**PIC18F1XK22/LF1XK22 Family
Silicon Errata and Data Sheet Clarification**

The PIC18F1XK22/LF1XK22 family devices that you have received conform functionally to the current Device Data Sheet (DS41365D), except for the anomalies described in this document.

FIGURE 1: INSTRUCTION CYCLE DELAY CALCULATION EXAMPLE

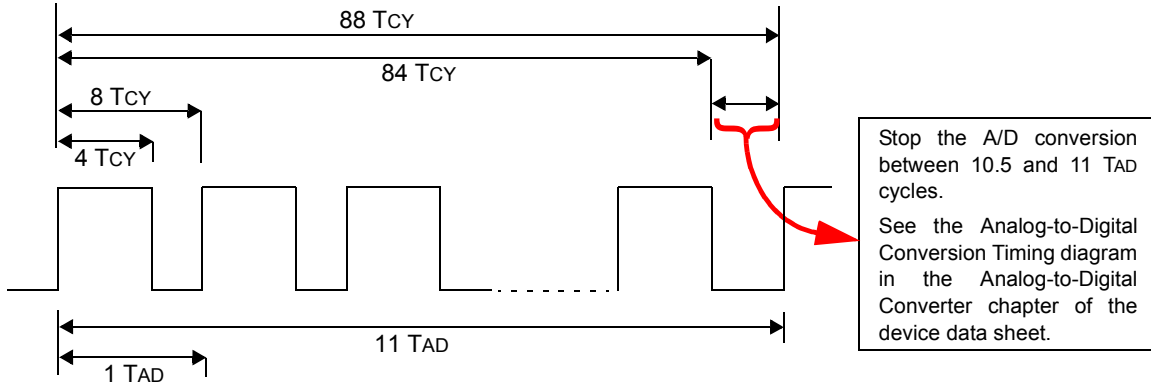
- 1.2 An ADC conversion may not complete under these conditions:

1. When Fosc is greater than 8 MHz and is the clock source used for the ADC converter.
2. The ADC is operating from its dedicated internal FRC oscillator and the device is not in Sleep mode (an Fosc frequency).

When this occurs, the ADC Interrupt Flag (ADIF) does not get set, the GO/DONE bit does not get cleared, and the conversion result does not get loaded into the ADRESH and ADRESL result registers.

Method 3: Method 3 is provided if the application cannot use Sleep mode and requires continuous operation at frequencies above 8 MHz. This method requires early termination of an ADC conversion. Provide a fixed time delay in software to stop the A-to-D conversion manually, after all 10 bits are converted, but before the conversion would complete automatically. The conversion is stopped by clearing the GO/DONE bit in software. The GO/DONE bit must be cleared during the last ½ TAD cycle, before the conversion would have completed automatically. Refer to Figure 1 for details.

In Figure 1, 88 instruction cycles (T_{cy}) will be required to complete the full conversion. Each TAD cycle consists of 8 T_{cy} periods. A fixed delay is provided to stop the A/D conversion after 86 instruction cycles and terminate the conversion at the correct time as shown in the figure above.

Note: The exact delay time will depend on the TAD divisor (ADCS) selection. The T_{cy} counts shown in the timing diagram above apply to this example only. Refer to Table 3 for the required delay counts for other configurations.
